Technical Bulletin / Bollettino Tecnico

ECAM Models

Date / Data: 22/09/2021

**New grinder with integrated thermal protector on ECAM models**

Grinder pn: AS00002955

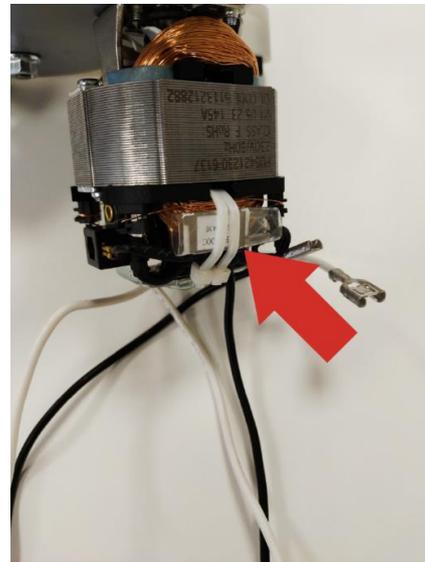
We inform you that it is available in DLS the new grinder with integrated thermal protector pn **AS00002955**.

POSITION OF BROWN CABLE WITH FUSE  
*POSIZIONE DEL CABLAGGIO MARRONE CON FUSIBILE*

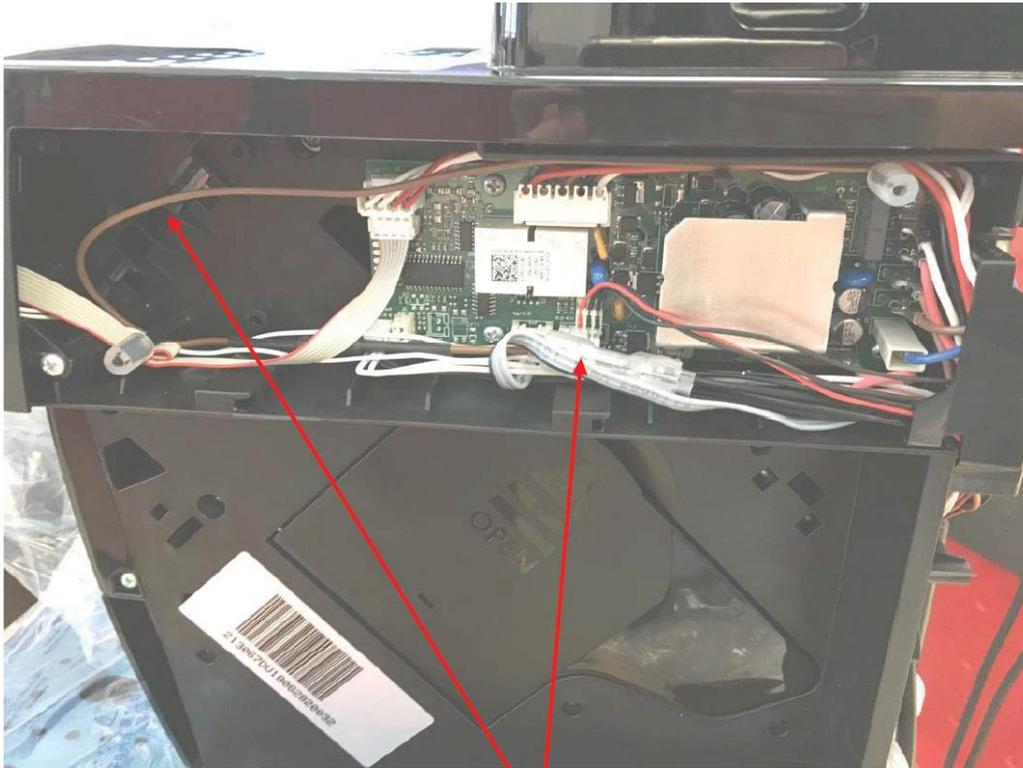
In case of replacement of a grinder with fuse placed along the wire it is necessary to remove the wire itself and connect the new grinder directly on the main PCB.

Macinino codice: AS00002955

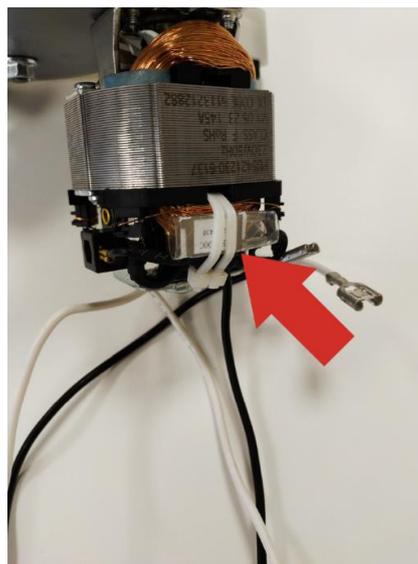
Vi informiamo che è disponibile in DLS il nuovo macinino con protettore termico integrato a codice **AS00002955**.

POSITION OF BROWN CABLE WITH FUSE  
*POSIZIONE DEL CABLAGGIO MARRONE CON FUSIBILE*

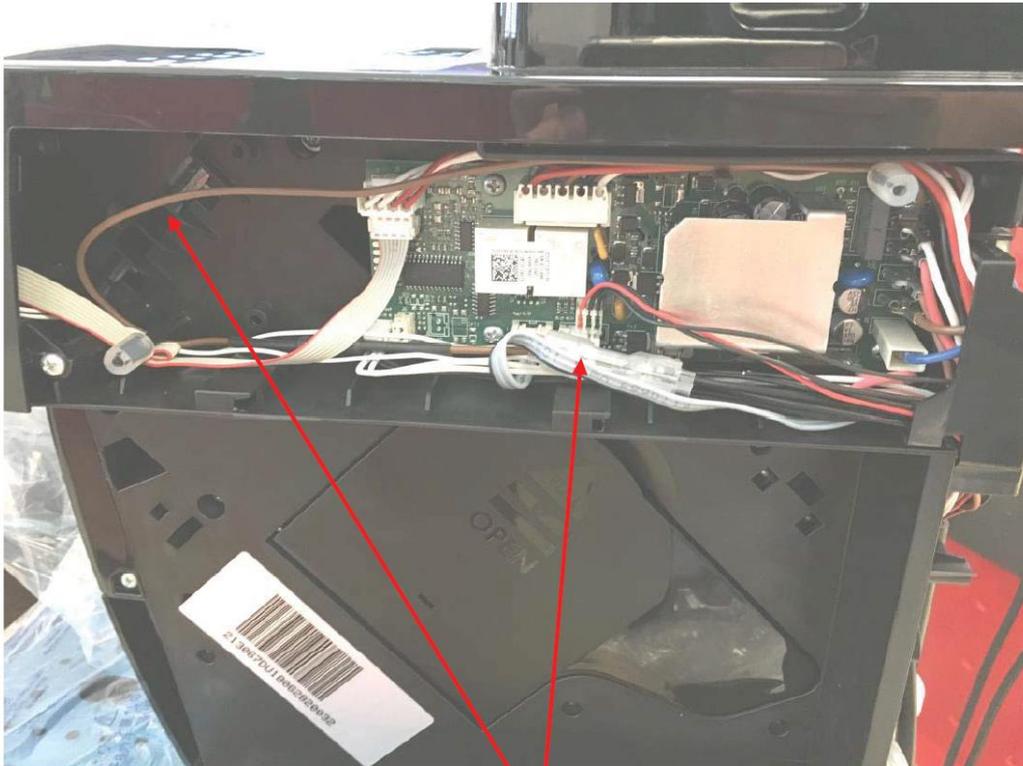
In caso di sostituzione di un macinino con fusibile posizionato lungo il cablaggio è necessario eliminare il cablaggio stesso e collegare il nuovo macinino direttamente alla main PCB.
